ADDENDUM 001 TO THE CONTRACT DOCUMENTS

Project: City of Unalaska - City Hall Snowmelt System
Addendum Issue Date: August 25, 2017
Issued for Bid Date: August 25, 2017
Bid Due Date: September 12, 2107 at 2:00pm (AKST)
Previous Addenda Issued: None
Issued By: Robert Lund, P.E.
City of Unalaska
PO Box 610
Unalaska, Alaska 99685

Contract: *City of Unalaska City Hall Snowmelt System*
Section: *Construction Drawings (Plan Sheets)*

EXTERIOR COVER

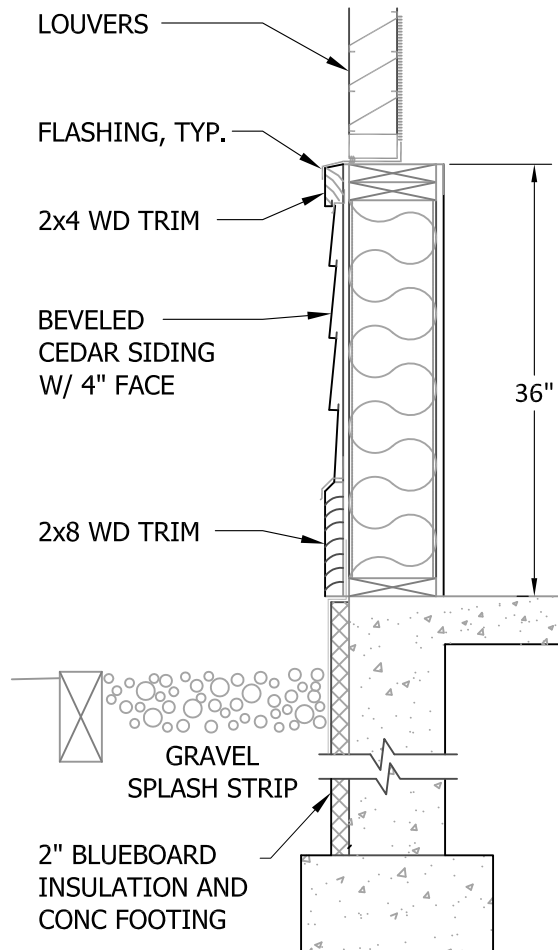
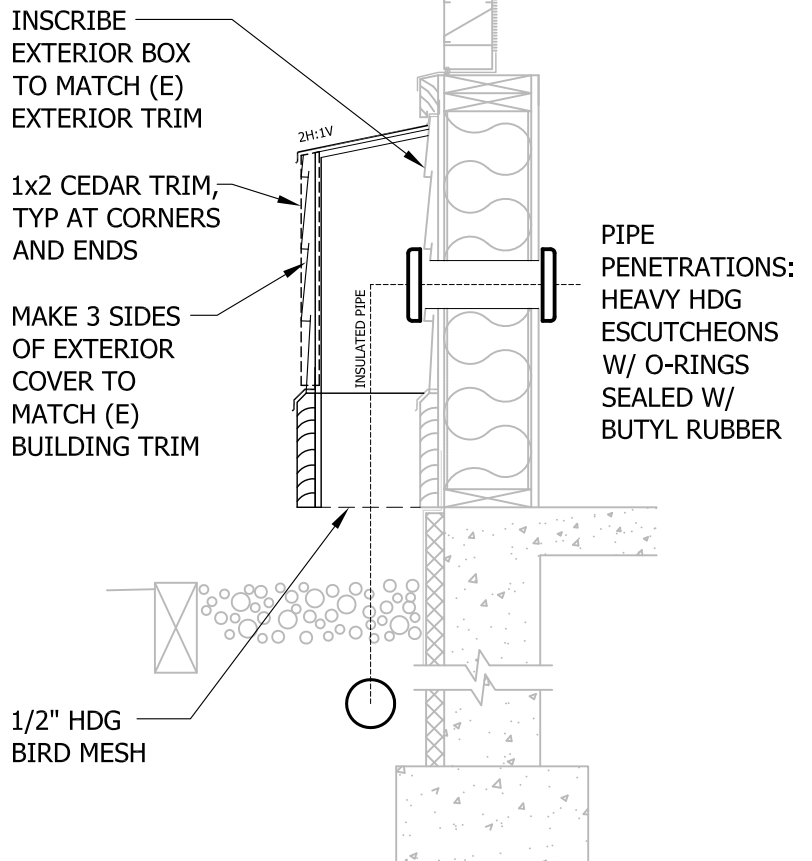
The exterior GS/GR lines were extended past a clear location to penetrate into the mechanical room. Install the GS/GR ends and the ¾" conduit inside UB-2. Turn pipes 180 degrees, run back underground to a clear location to penetrate into the Mechanical Room. Extend them above grade to the building penetrations. Above grade use rigid metallic conduit for signal and SCH 40 304 SS for GS/GR. Insulate the GS/GR lines.

*Install an exterior cover over the penetrations per attached detail **Exterior Cover**.*

1. EXTERIOR COVER IS A 9" DEEP x 36" TALL x 16" ± WIDE 1/2" TREATED PLYWOOD BOX TRIMMED TO MATCH (E) BUILDING.
2. FRAME INTERIOR W/ TREATED 2x4 WD
3. HARDWARE ALL HDG
4. PRIMER AND PAINT TO MATCH EXTERIOR SIDING, TRIM AND FLASHING
5. SEAL JOINTS W/ BUTYL RUBBER SEALANT
